Turbo HD DVR V4.84.001build250821 Release Notes

Reason of Upgrade

Modify the product design, add new functions and optimize the user experience.

2. AcuSearch function integration with HCT platform

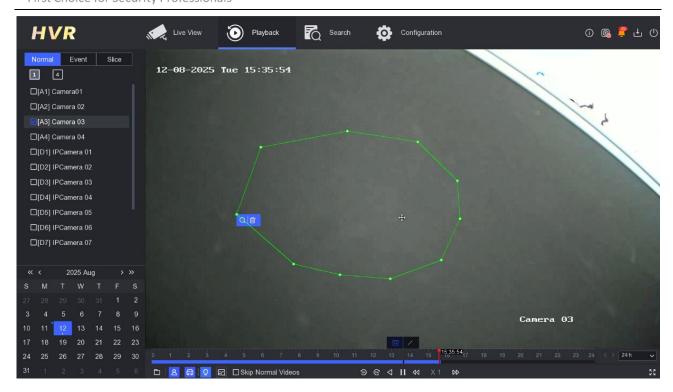
- a. The AcuSearch function supports integration with the HCT platform.
- b. HCT Version: 6.10.0
- c. Device Model Range: 72HQ/HU-M/XT, 72HU-M/PXT

5. Supports Khmer language for the Cambodia region

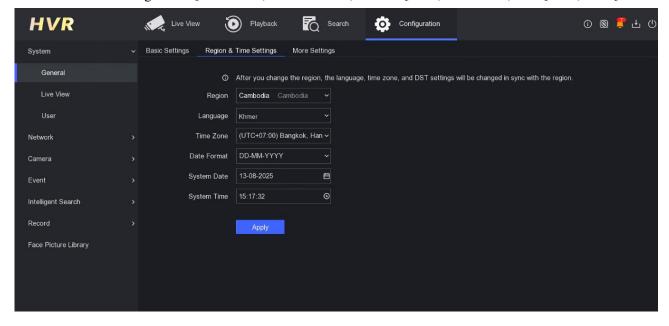
- a. The local interface for Asian language packages supports Khmer in the Cambodia region
- b. Device Model Range: 72HQ/HU-M/XT, 72HU-M/PXT, 71/72HQ-M/T, 72HU-M/T, 71HQ-M/S, 72HQ-M/E

6. Email service address preset general mailbox

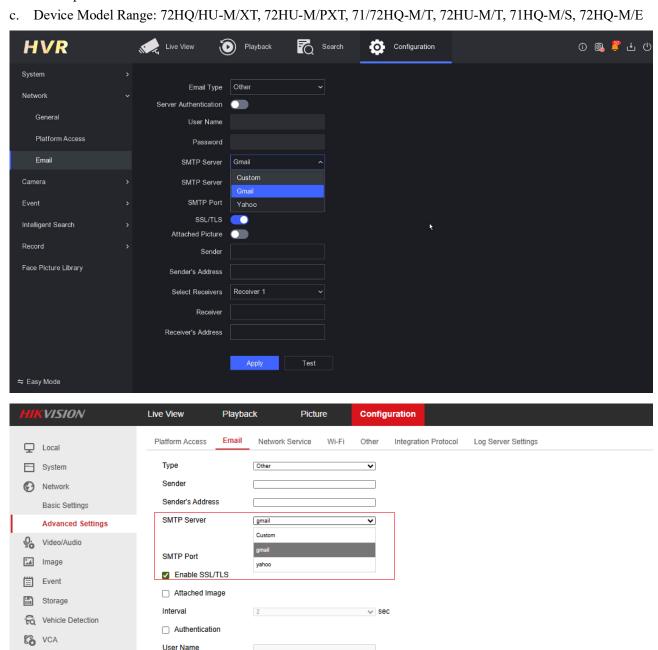
- a. The SMTP Server dropdown at the Email location presets Gmail and Yahoo email
- b. Select the preset email account to automatically associate SSL/TLS and port number configurations, email preset configuration:

Gmail port number: 587 Enable SSL/TLS

Yahoo port number: 587 Enable SSL/TLS

7. Add display of device short serial number in system information

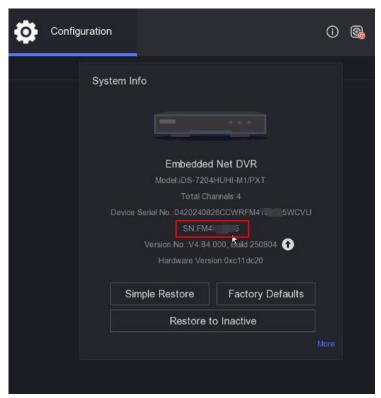
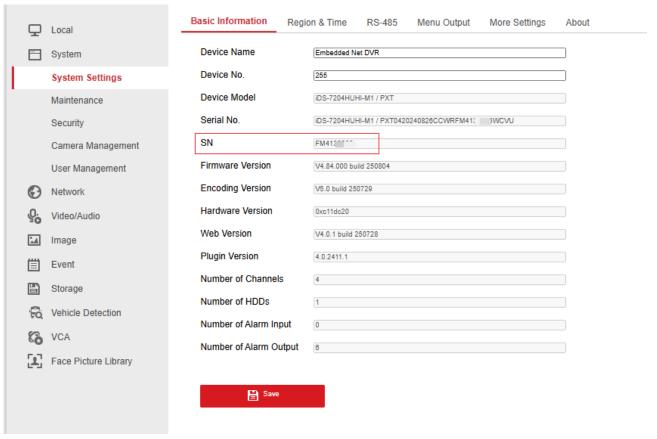
- a. Add short serial number display in system information for WEB and local
- b. Device Model Range: 72HQ/HU-M/XT、72HU-M/PXT、71/72HQ-M/T、72HU-M/T、71HQ-M/S、72HQ-M/E

8. New negative pressure configuration item added for POC model

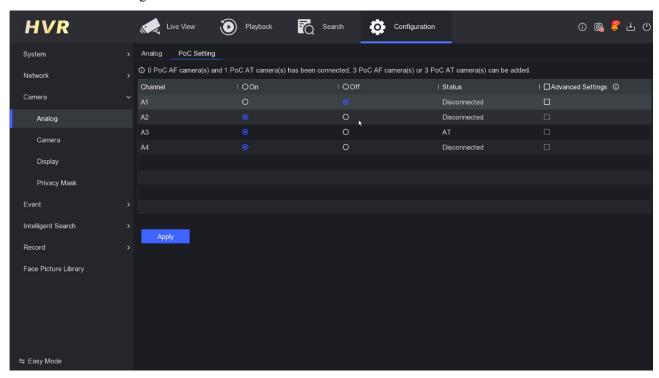
To resolve the issue of image distortion when POC models are used with AC-coupled cameras, a new negative pressure disable configuration has been added to the POC disable configuration interface. This configuration can only be enabled when PoC is disabled.

- a. After the negative pressure configuration is disabled, some front-end cameras (including PTZ dome cameras) may experience PTZ malfunction, which is a negative effect of enabling this configuration;
- b. After the negative pressure configuration is disabled, the AC coupled camera plug-in and plug-out signal will take effect in about 15 seconds to ensure normal image display;
- c. Device Model Range: 7204HU-M/PXT

9. Outlook email supports the OAuth2.0 authentication method

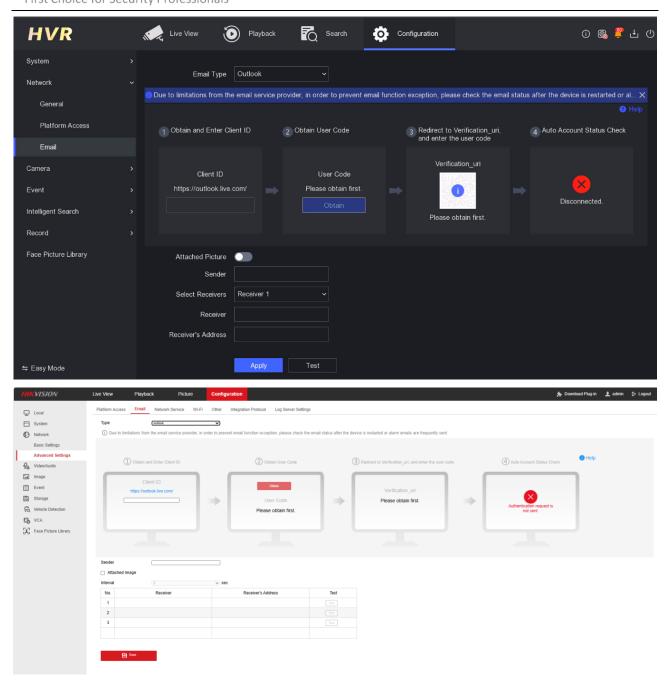
- a. Outlook email's original account password method is no longer supported and has been upgraded to use the new OAuth2.0 authentication method for authentication
- b. Device Model Range: 72HQ/HU-M/XT, 72HU-M/PXT, 71/72HQ-M/T, 72HU-M/T, 71HQ-M/S, 72HQ-M/E

10. Search Interface Function Optimization

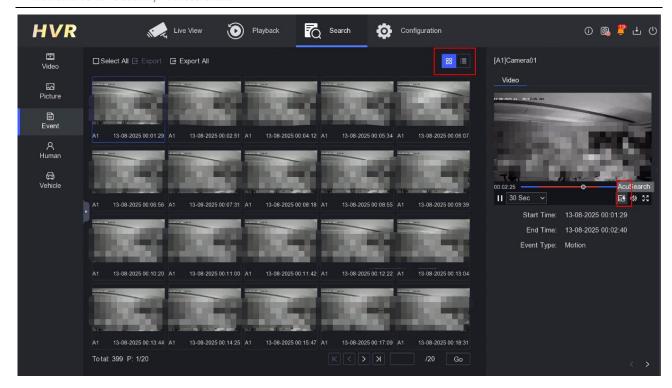
- a. Add AcuSearch function entry in the small window playback of event search result for user convenience
- b. Double-click to zoom in and double-click to zoom out function are added to the playback small window
- c. Right-click mouse to add return function
- d. Video, image, and event search results add chart mode

13. Supports PTRZ IPC camera configuration

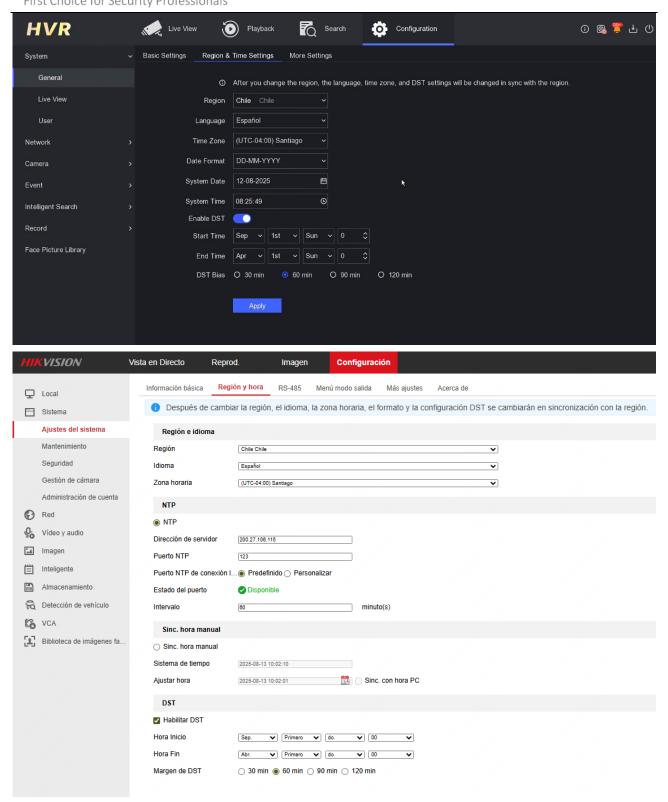
- a. Support PTRZ camera configuration (including left, right and R), after connecting the PTRZ camera, the PTZ menu name is changed to PTRZ
- b. Supports PTZ lock, when locked, operating PTRZ displays PTRZ is locked
- c. Device Model Range: 72HQ/HU-M/XT, 72HU-M/PXT

15. Add a prompt description in the advanced configuration of the recording schedule

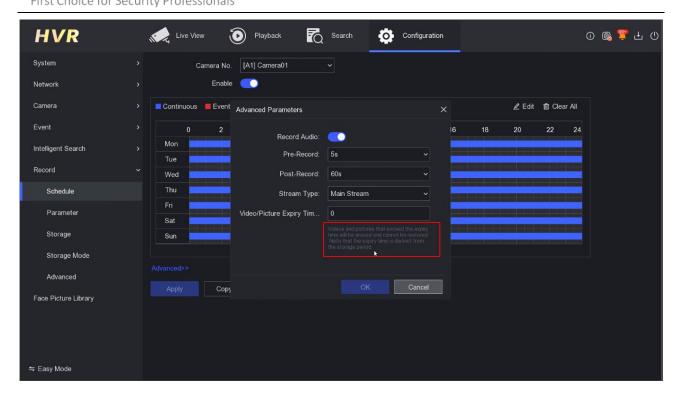
- a. Added a note in the advanced configuration of the recording schedule: Videos and pictures that exceed the expiry time will be erased and cannot be restored. Note that the expiry time is distinct from the storage period.
- b. Device model range: 72HQ/HU/HT-M/XT, 72HU-M/PXT, 71/72HQ-M/T, 72HU-M/T, 71HQ-M/S, 72HQ-M/E
